PROPOSAL FOR ENVIRONMENTAL CLEARANCE FOR KUSHABHADRA RIVER SAND BED OVER AN AREA OF 55 ACRES /22.26 HA. IN VILLAGE BHUBANPUR OF BALIANTA TAHASIL IN THE DISTRICT OF KHORDHA (TOR).

REPORT OF THE SUB COMMITTEE ON THE FIELD VISIT TO KUSABHADRA RIVER SAND QUARRY LOCATED ON KUSABHDRA RIVER

SEIAA File No. SIA/OR/MIN/71311/2022

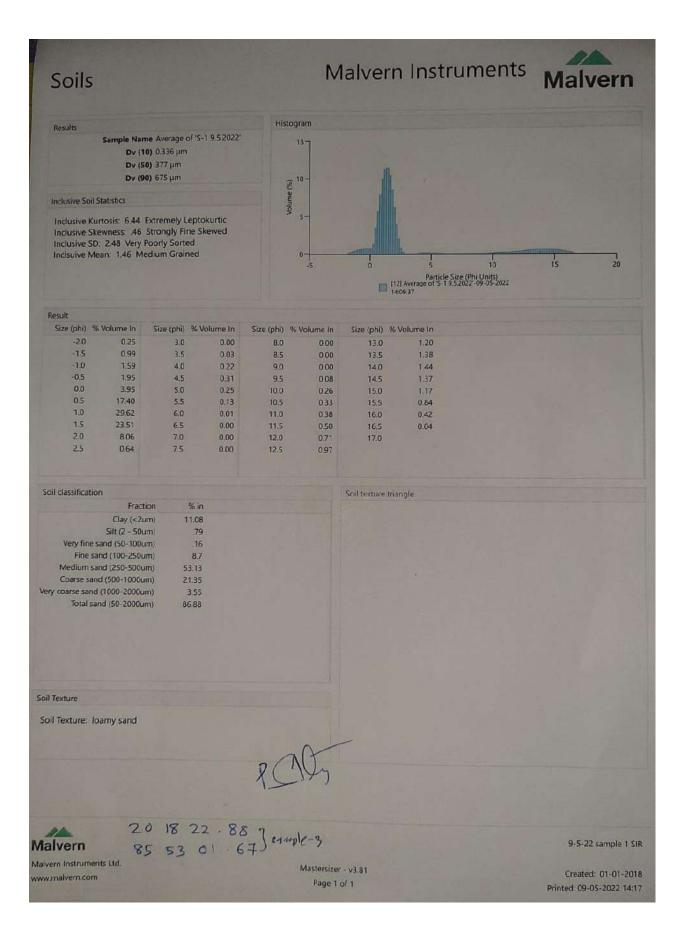
To ensure grain size of the sand in the quarry area, three samples were collected and were analysed using Particle size Analyser (Malvern). Reports of the three samples are also attached. Reports indicate that except for sample 3, sand percentage in sample 1 and sample 2 are respectively 99.94% and 98.53%. Percentage of sand in sample 3 is 86.88% while clay percentage is 11.08%. Sand in all the three samples is predominantly in the range fine sand to coarse sand. From the above grain size distribution and the deposition of sand (thickness more than 2.5m), the quarry is fit for mining.

At present the flow in Kusabhadra river is not perennial and is mostly blocked at the confluence due to deposition of sand. Hence mining of sand shall facilitate free flow of river water, enhance the possibility of replenishment and reduce the water logging in the upstream.

However, considering the sensitivity of the areas located within 500m from the sand quarry, the proponent should take appropriate preventive measure for the safe guard of the embankments on High Tech hospital side as well as on the village side of Balianta.

Following are some of the photographs of the site indicating huge sand deposit, blockage of the river flow at the confluence, the river embankment, road bridge at a distance and collection of sand samples.
